Re: Final Plat S/D 87-50 - GOLDEN HILLS 4TH ADDITION

GOLDEN HILLS 4TH ADDITION

Final Plat
SUBDIVISION REPORT

S/D No.: 87-50 Name: GOLDEN HILLS 4TH ADDITION

FINAL PLAT

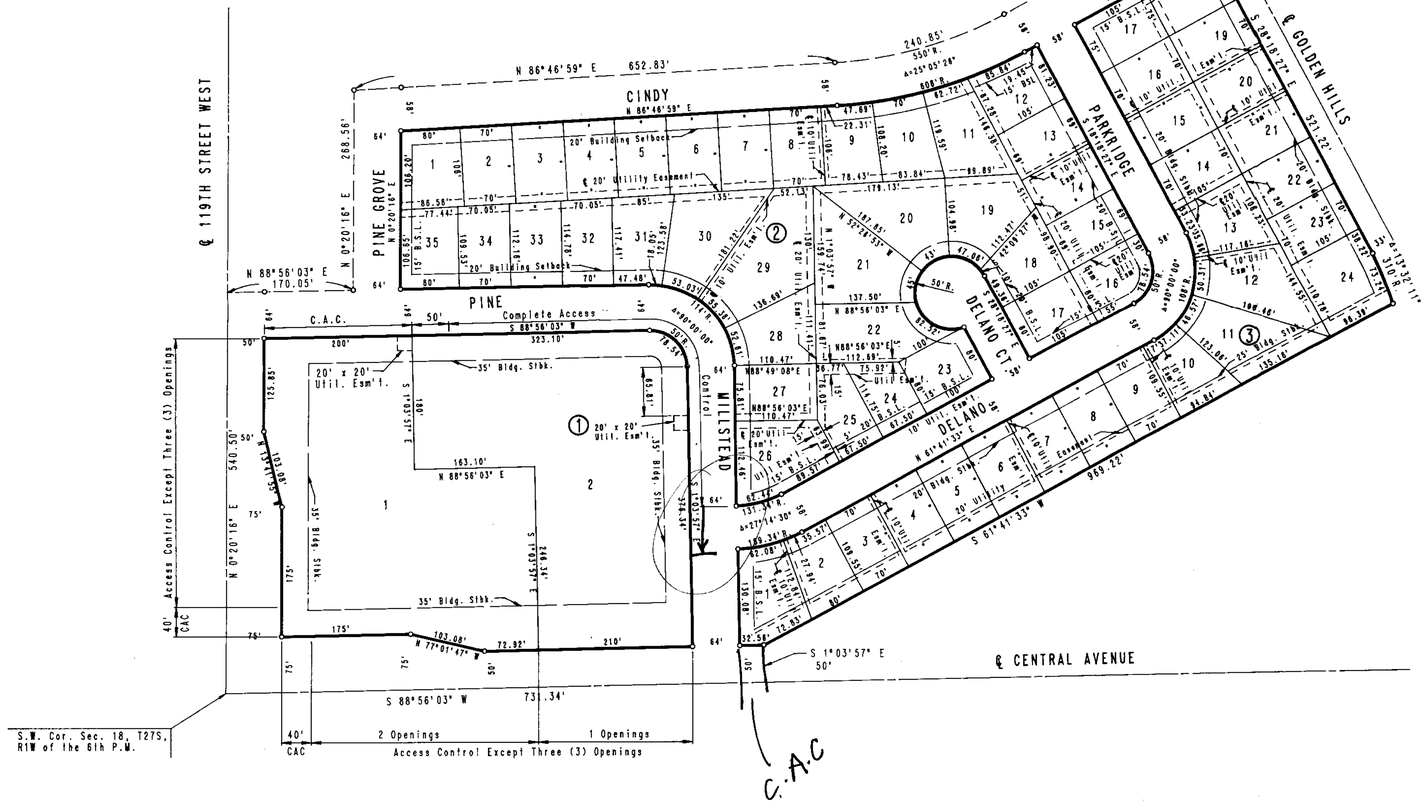
K. On the final plat tracing, the building setback being platted on Lot 2, Block 1, shall be dimensioned from the south line of the lot. The building setback being platted on the north 125 feet of Lot 1, Block 1, shall be dimensioned from the west line of that lot.

L. It should be noted that the plattor is proposing to plat a 20-foot front yard setback on the residentially zoned lots. The platting of this reduced building setback is in character with the other Golden Hills plats in this area.

N. When the associated zone change was approved by the Planning Commission, staff was instructed to establish access controls to Pine and Millstead Street from the commercial and office zoned property. The access control proposed to Pine Street from Lots 1 and 2, Block 1 is acceptable as depicted on the final plat. For Millstead Street, however, the final plat tracing shall extend the area of "complete access control" 58 feet further south, so as to avoid the construction of a driveway directly west of Delano Street's intersection with Millstead.

O. Any relocation, lowering or encasement of the pipeline in the pipeline easement along the southerly line of Block 3, that is made necessary by this development, will not be at the expense of the City.

Q. Perimeter closure computations shall be submitted with the final plat tracing. Section 5-101(C).

S. The representative from the City Engineer's office should be prepared to comment on the status of the applicant's drainage plan. Specifically, what drainage guarantees are required to be guaranteed with this plat.

A. The applicant shall guarantee the extension of sanitary sewer to serve the lots being platted.

B. The applicant shall guarantee the extension of City water to serve the lots being platted.

C. The applicant shall guarantee the paving of the proposed interior streets.

D. The applicant shall guarantee construction of the storm sewers required by this plat.

E. The applicant shall guarantee any drainage improvements required by the platting of this property.

F. The applicant shall submit a sidewalk certificate stating that a sidewalk will be constructed on the westerly side of Golden Hills, adjacent to Lots 18 through 24, Block 3. This sidewalk is required since Golden Hills is classified as a collector street.

G. The Pine/Millstead Street paving petition shall provide for the construction of a sidewalk on the south and west sides of these streets. These sidewalks are required because of the approved commercial and office zoning.

I. The applicant shall submit a covenant which provides for four (4) off-street parking spaces per dwelling unit on each lot which abuts a 58-foot street. The covenant shall inventory the affected lots by lot and block number and shall state that the covenant runs with the land and is binding on future owners and assigns.

J. The final plat tracing shall indicate the platting of "complete access control" to Central Avenue across the south line of Lot 1, Block 3. The platting of this access control shall be referenced in the plattor's text.
